Sizewell C (SZC)

Planning Inspectorate Reference: *EN010012*

Deadline 8 – 24 September 2021

East Suffolk Council comments on Deadline 7 submissions from the Applicant

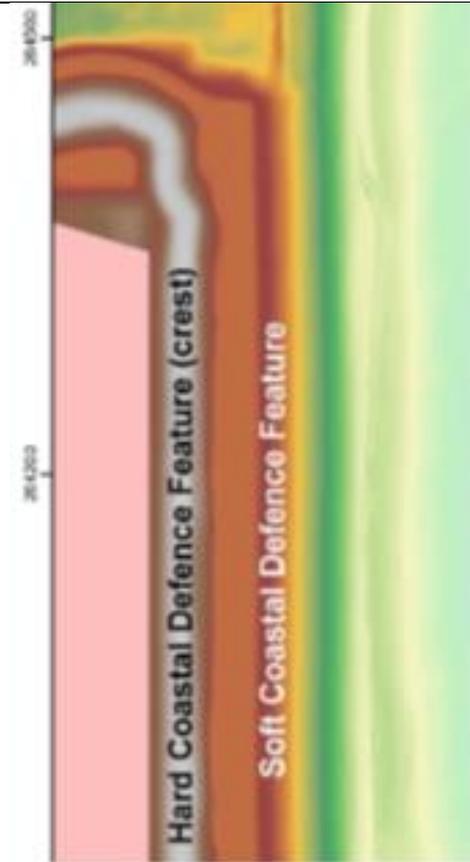
<p>5</p> <p>13</p>	<p>Fig. i</p>	<p style="text-align: center;">TR544: PRELIMINARY SCDF DESIGN NOT PROTECTIVELY MARKED</p> <p>Figure i: Schematic cross-section of the hard and soft coastal defence feature (HCDF and SCDF). The SCDF (yellow) is conceptually divided into two volumes, separated by the dividing SCDF recharge threshold (as the threshold is volumetric, the line is shown for illustrative purposes only, i.e., many different beach profile shapes can produce the threshold volume). The SCDF buffer layer (whose volume is V_{buffer}) sits to landward and is not intended to be exposed, whilst the SCDF sediment to seaward is sacrificial (V_{sacr}) and would be replenished once the recharge threshold has been reached. The dashed green line running through the yellow SCDF is the present-day topographic cross-section.</p>	
<p>18</p>		<p>Accepting that the diagram is a schematic, it nevertheless raises a number of questions: The HCDF structure appears to be drawn to natural scale, e.g. with a 1:3 seaward slope. Equally the</p>	<p>Clarification sought, preferably by production of a more realistic illustration that uses natural scale throughout.</p>

<p>seaward face of the Sacrificial layer at ~1:7 is not unreasonable. The principle of “volume definition” is reasonable but the schematic is misleading in respect of the implied SCDF threshold (even with the caveat):</p> <p>There is no consideration in report of SCDF viability with adapted HCDF profile</p> <p>Two points in relation to “landscaping”: The coastal path runs beneath the landscaping.</p> <p>The landscaping runs over the crest at a thickness of 2m (or 2.9m if the unlabelled layer beneath it is also landscaping). If not removed before the HCDF becomes an active defence, this material could seriously affect the hydraulic performance of the HCDF (run up and overtopping).</p>	<p>This diagram will be changed (re. Applicant/ESC meeting 10.09.2021). Query and connected comments are withdrawn.</p> <p>Clarification on the location of the landscaping in relation to the coastal path.</p> <p>Further information regarding long term future management of the landscaping layer.</p> <p>Except where noted, the above points apply to the Revision 3.0 version of the report.</p>
